The Village of Pinehurst  
Engineering Standards and Specifications Manual

Adopted: August 24, 2004  
Amended: September 29, 2010  
Amended: October 27, 2010  
Amended: December 8, 2015

**ORDINANCE #10-55:**

**AN ORDINANCE AMENDING THE PINEHURST ENGINEERING STANDARDS MANUAL AS IT PERTAINS TO SECTIONS 6, 7 AND 8 AND STANDARD DETAILS # 3.05, 6.04, 6.05, 6.06, 6.08 AND 7.07.**

REV	DESCRIPTION	DATE	APPROVED BY
△	MODIFY SEWER, ADD NOTE 2	08/10	MSA
NOT TO SCALE DWG NO. 3.05		SHEET 1 OF 1

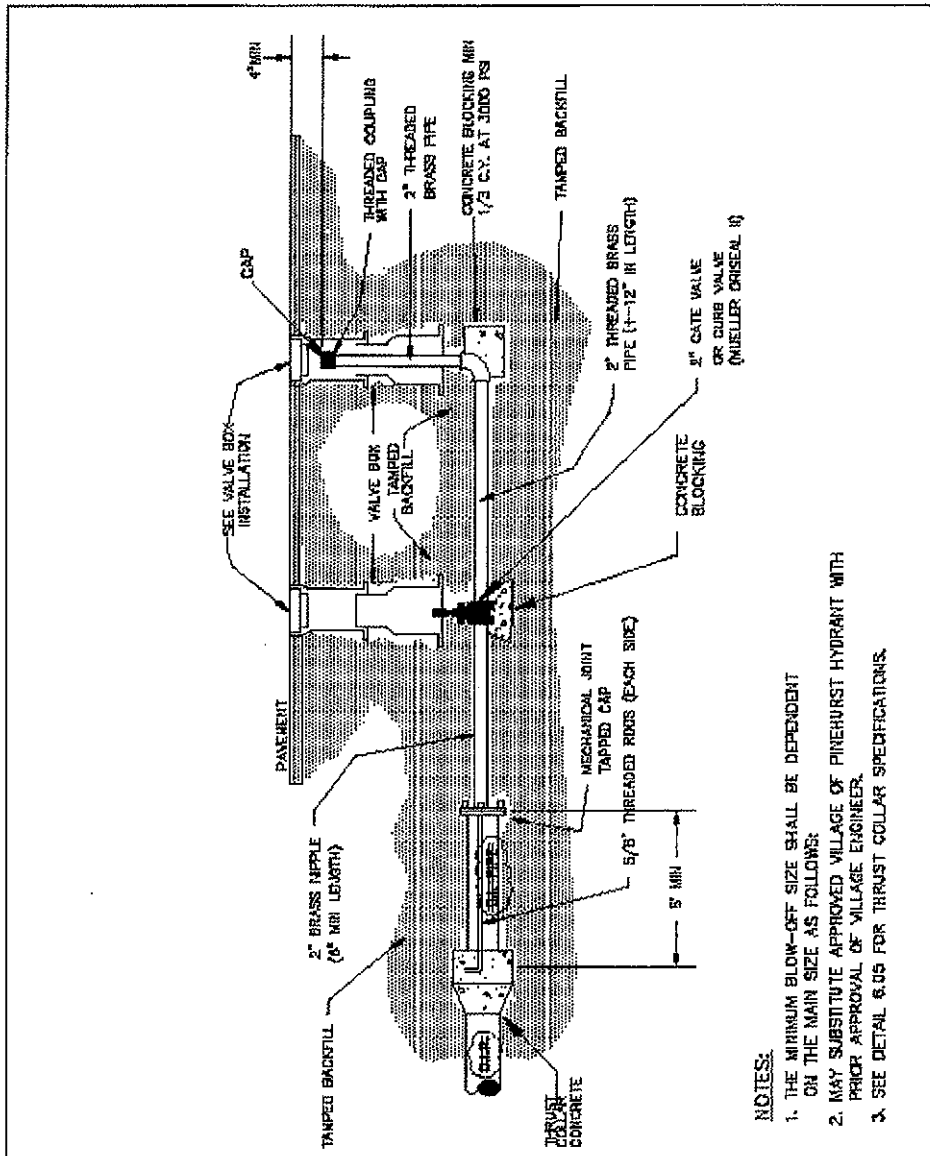
**SECTION 4.** That the Engineering Standards Manual of the Village of Pinehurst be and the same hereby is amended by adding the following text amendment to Standard Details # 3.05, 6.04, 6.05, 6.06, 6.08 and 7.07 :

**STANDARD 2"  
BLOWOFF  
ASSEMBLY**

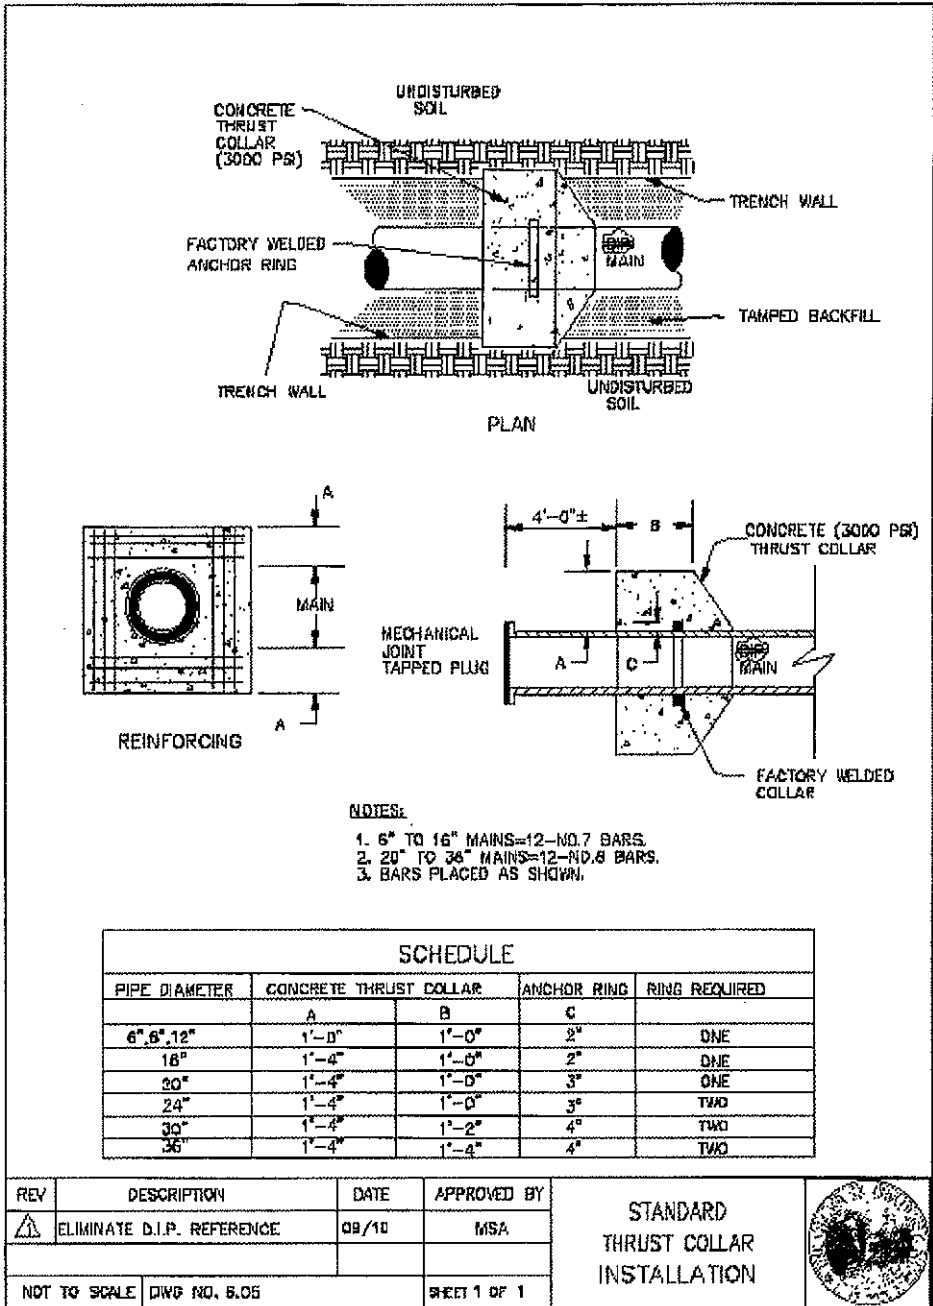
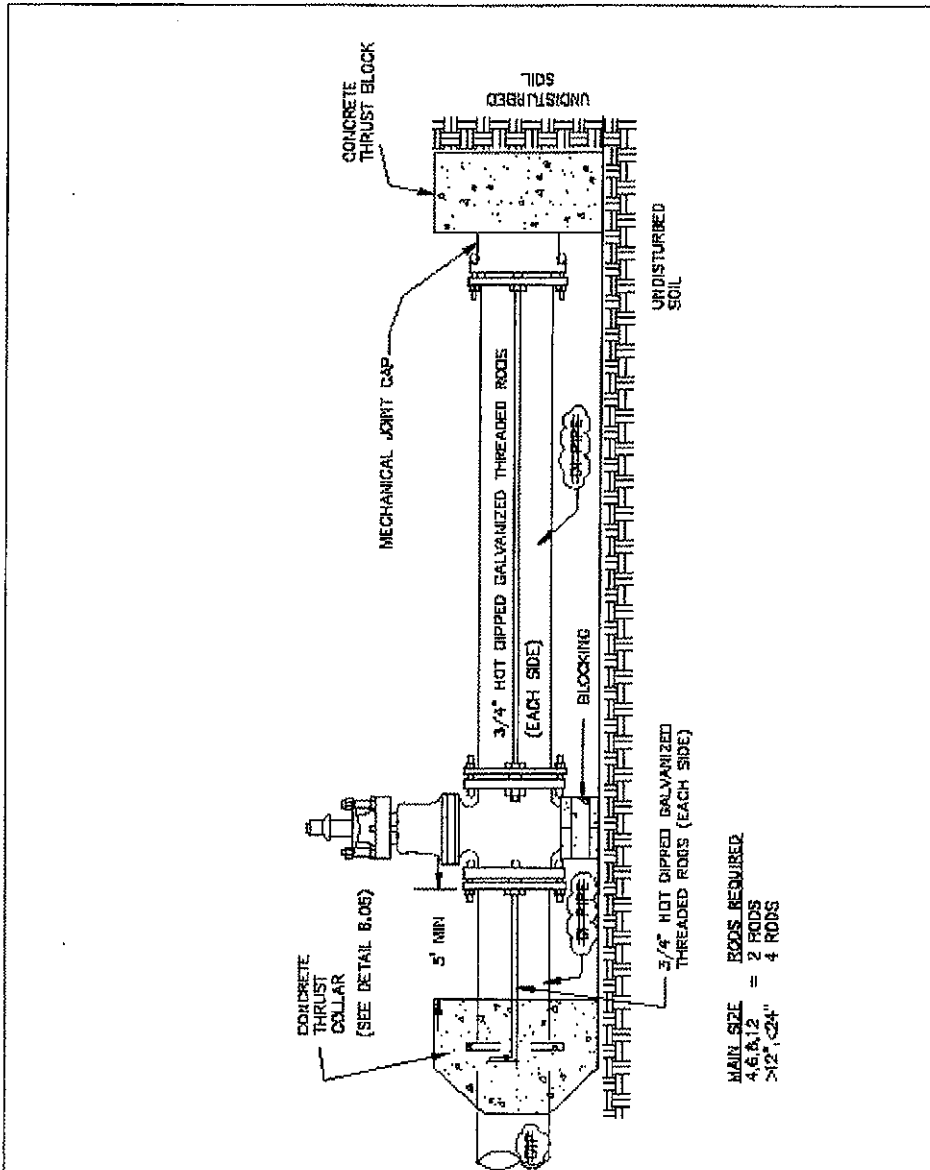
REV	DESCRIPTION	DATE	APPROVED BY
△	ELIMINATE D.I.P. REFERENCE	09/10	MSA
	NDT TO SCALE	DWG NO. 8.08	SHEET 1 OF 1

STANDARD  
 CAPPING  
 DETAIL

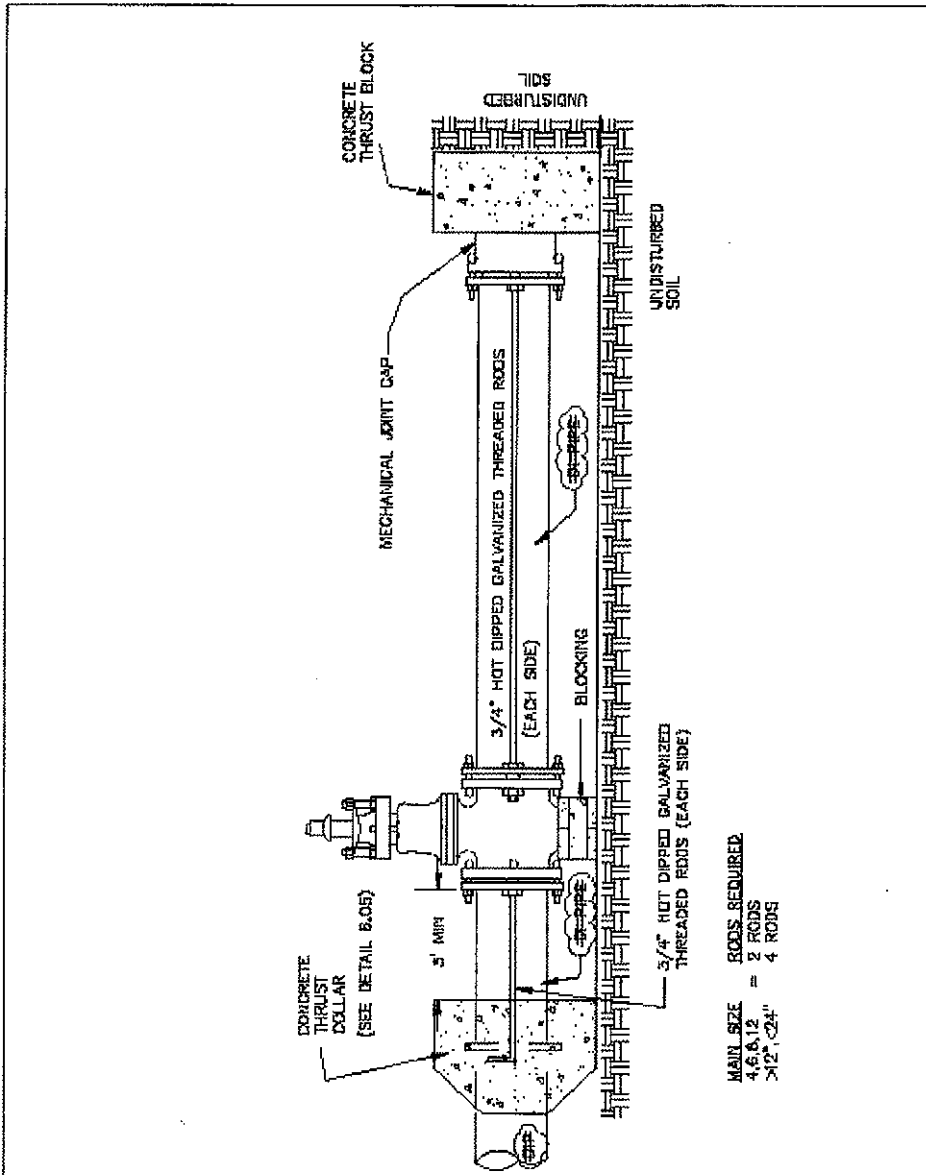
REV	DESCRIPTION	DATE	APPROVED BY	STANDARD CAPPING DETAIL	
△	ELIMINATE D.I.P. REFERENCE	01/20	MSA		
	NOT TO SCALE	DWG NO. 8.05	SHEET 1 OF 1

REV	DESCRIPTION	DATE	APPROVED BY	CUL-DE-SAC LOCAL RESIDENTIAL DETAIL	
△	ADD NOTE #4	08/10	MSA		
NOT TO SCALE		DWG NO. 3.02-A	SHEET 1 OF 1

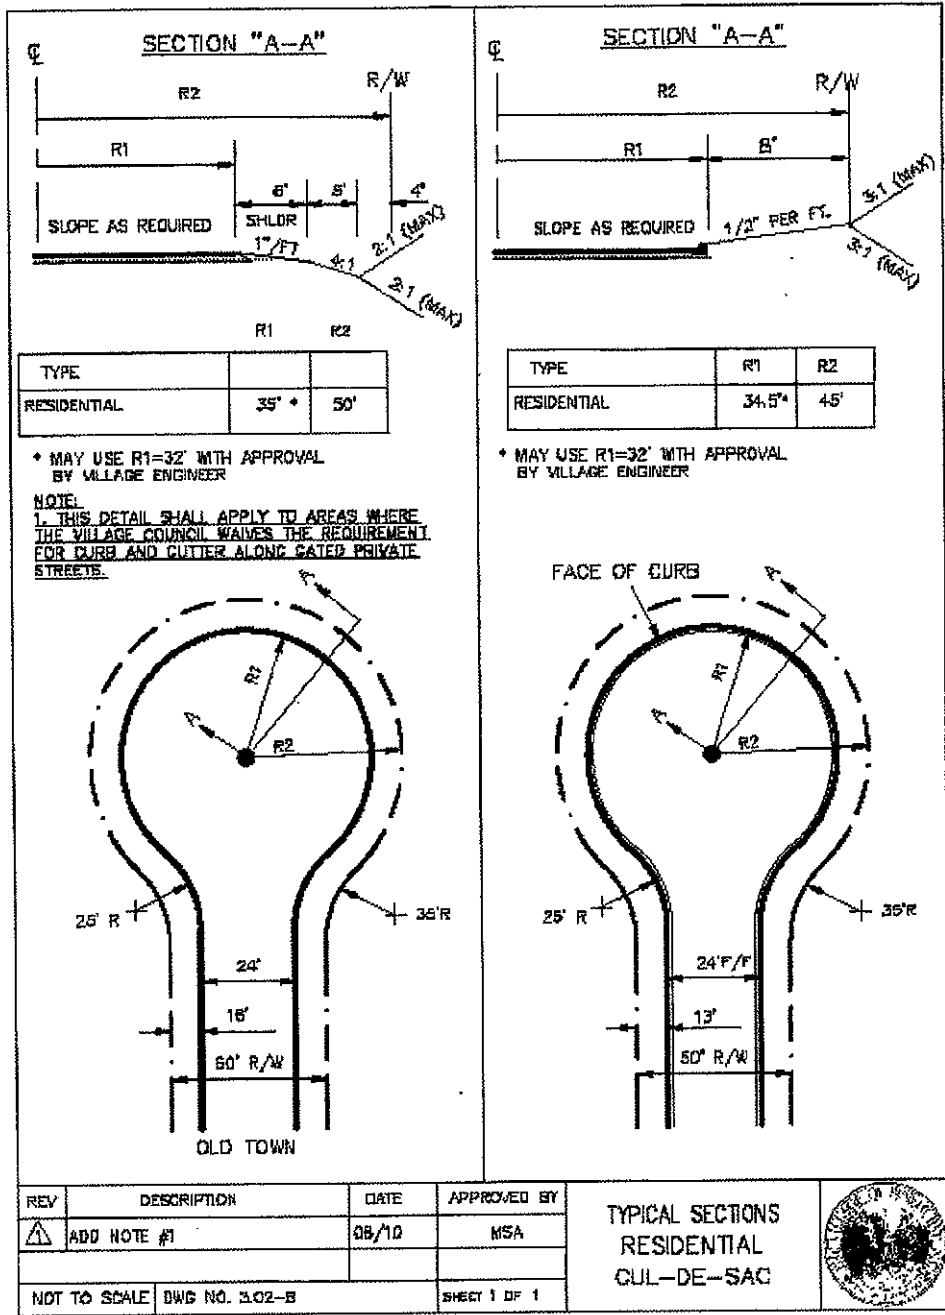
- NOTES:**
1. CURB AND GUTTER STREETS SHALL BE 24" STANDARD CURB AND GUTTER. (SEE DETAIL 4.03).
  2. THE CROWN FOR PAVEMENT SHALL BE 1/4" PER FT FROM THE CENTER OF THE CUL-DE-SAC.
  3. MAXIMUM CUL-DE-SAC LENGTH IS 500'.
  4. THE DITCH TYPE/OLD TOWN DETAIL SHALL APPLY TO AREAS WHERE THE VILLAGE COUNCIL WAIVES THE REQUIREMENT FOR CURB AND GUTTER ALONG GATED PRIVATE STREETS.
